VILLAGE OF BARTLETT

Stearns Road/ RT. 59 IDOT Improvements

COMMUNITY DEVELOPMENT MEMORANDUM

RE: REVISED Rt. 59 and Stearns Road Intersection Improvements

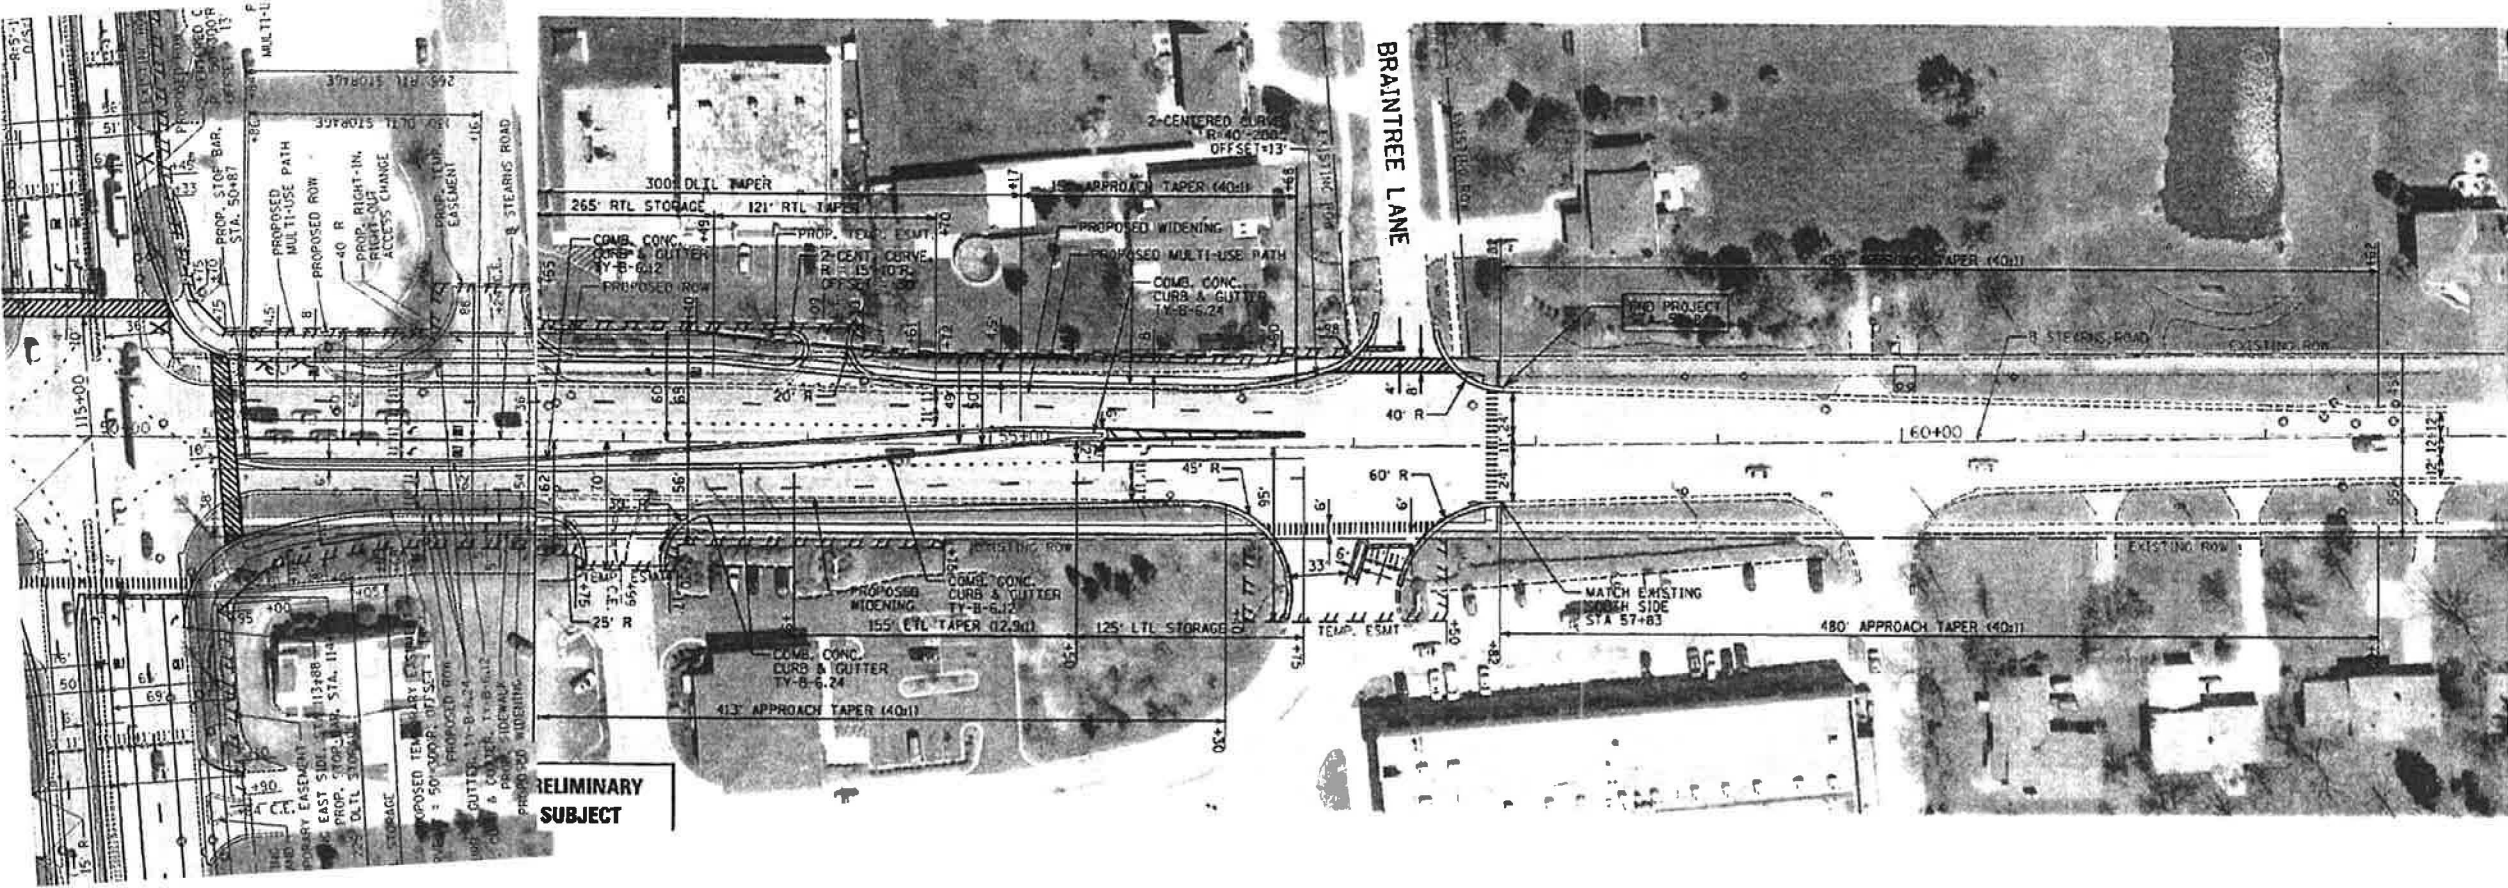
The revised access drawing was reviewed by Staff and Brent Coulter, the Village's traffic consultant. As with any plan to revise a complicated access problem there are concerns expressed with the revisions. This revised set of plans provides for an ingress and egress to the shopping center and the new Walgreen's which is an improvement

over the existing conditions. However, there are still some traffic movement conflicts with entering the shopping center during peak hours and crossing the additional lanes of traffic that will be constructed with the intersection improvement. (see **Potential Sight Line Issue** exhibit and **Median Re-design** exhibit)

Original Design Plan - Stearns Road East of Route 59

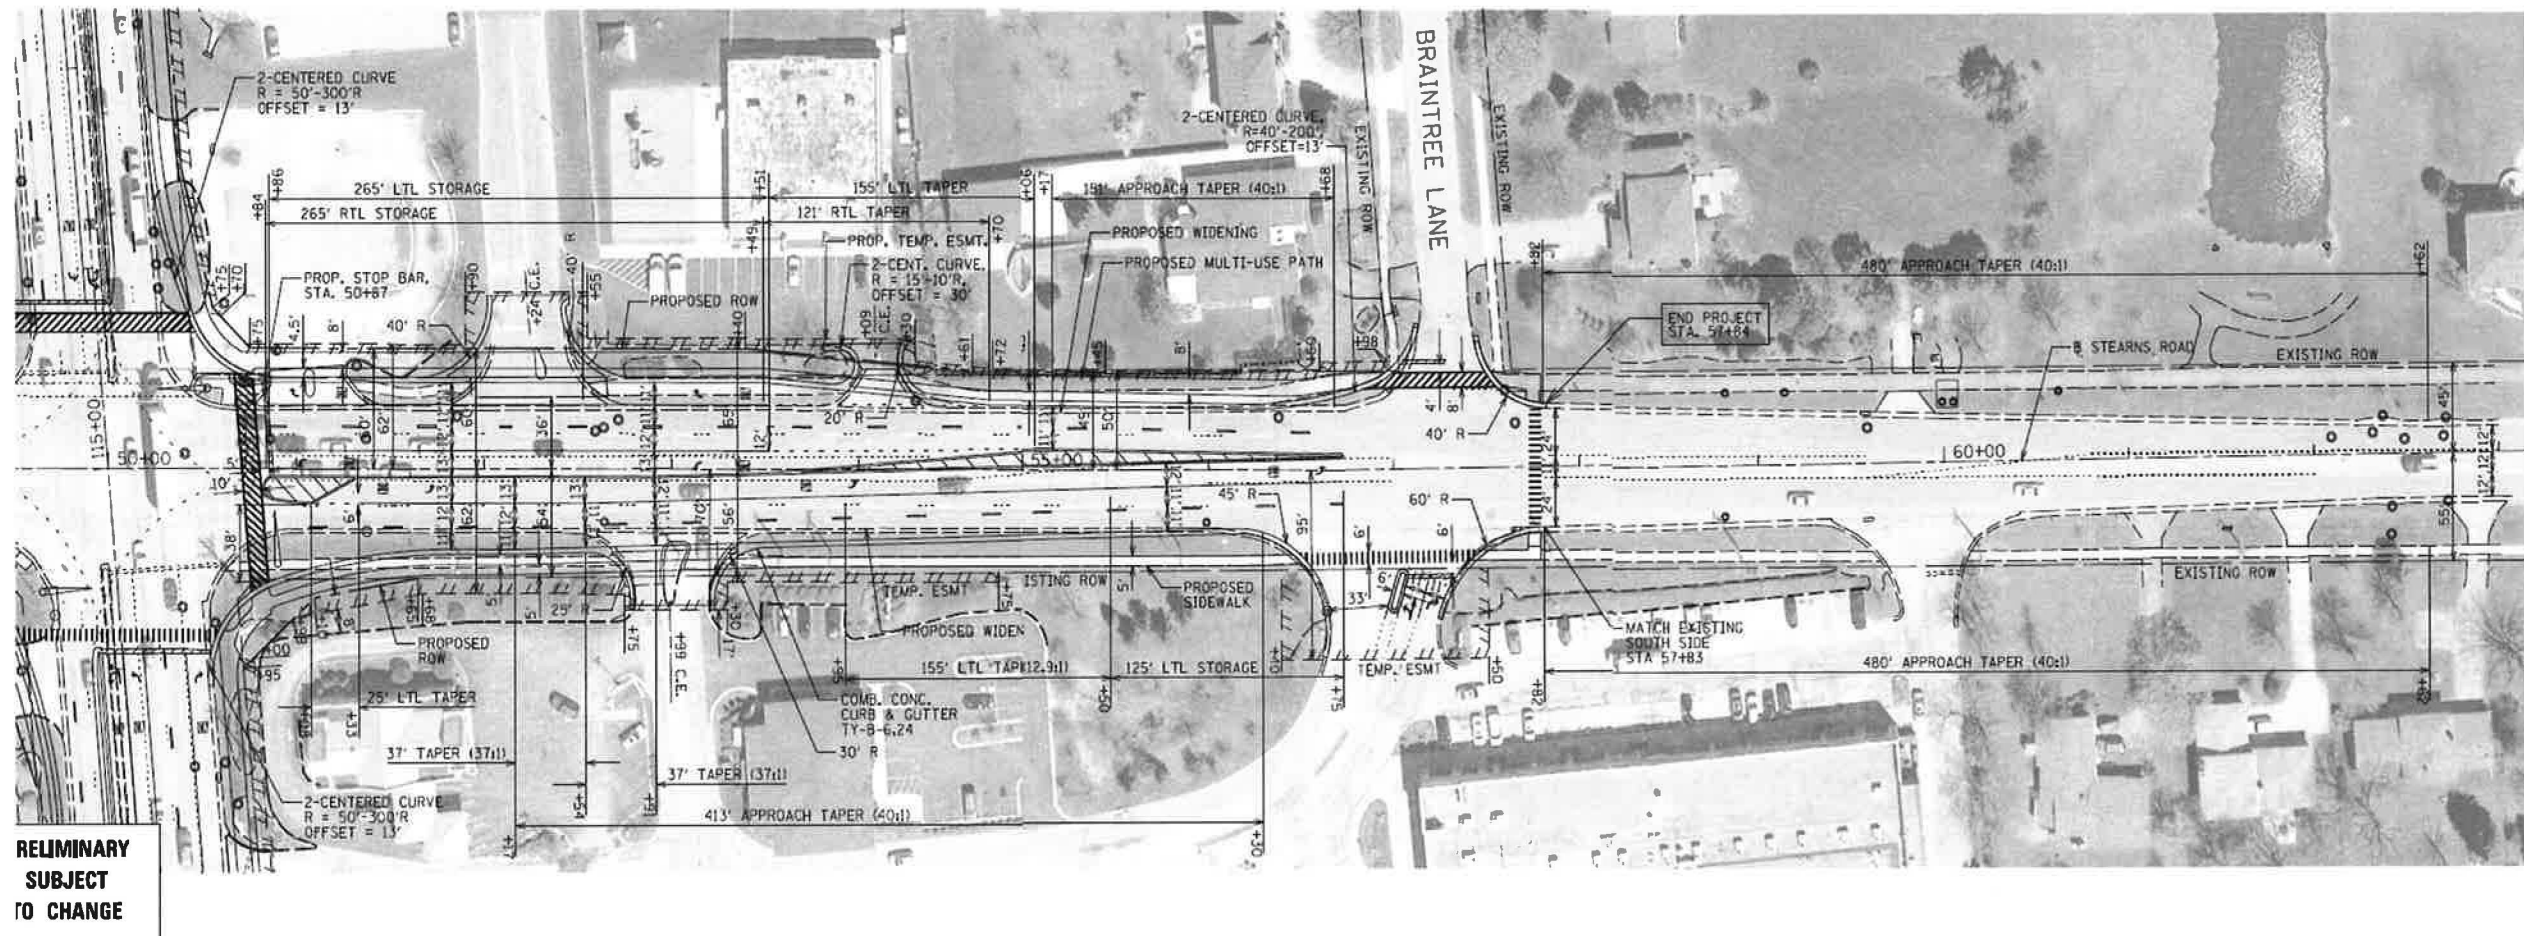
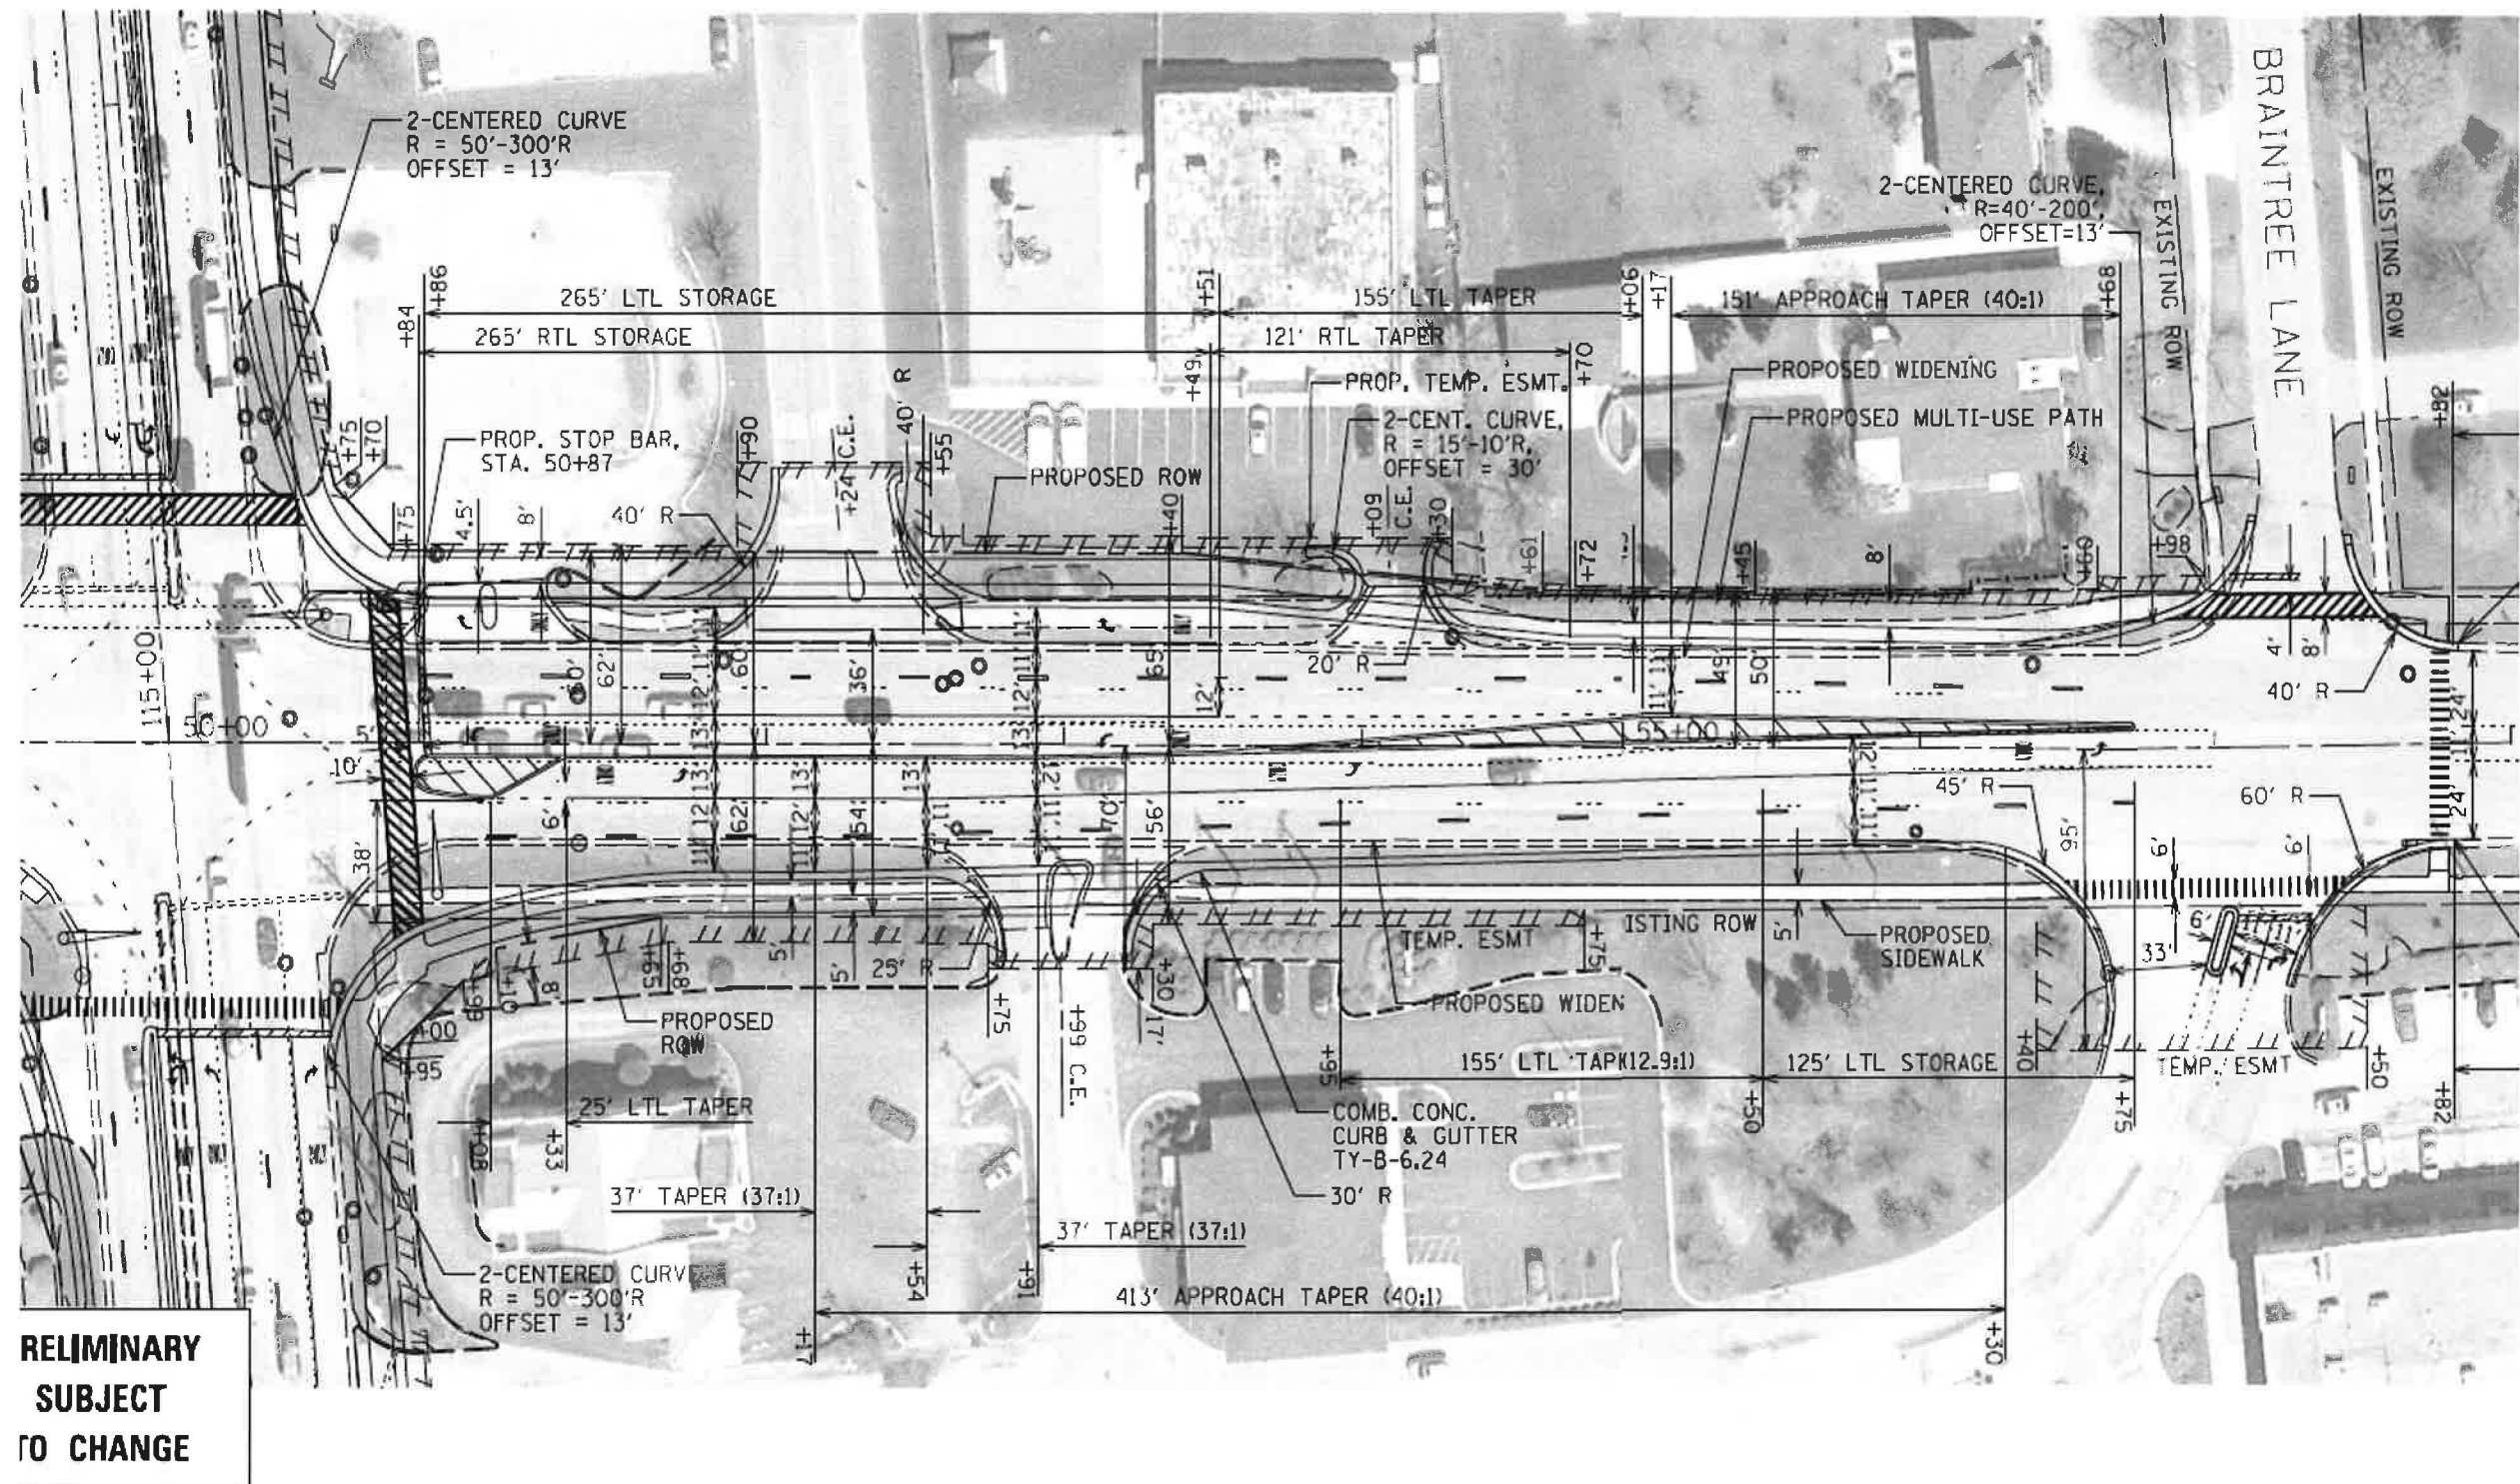
The proposed IDOT plans showed that the left turn from Stearns Road into the Brewster Creek Shopping Center would be eliminated and that access would be from the Rt. 59 entrances to the shopping center, Norwood Lane and westbound from Stearns Road with a right-in right-out access (see attached **Original Design** plan).
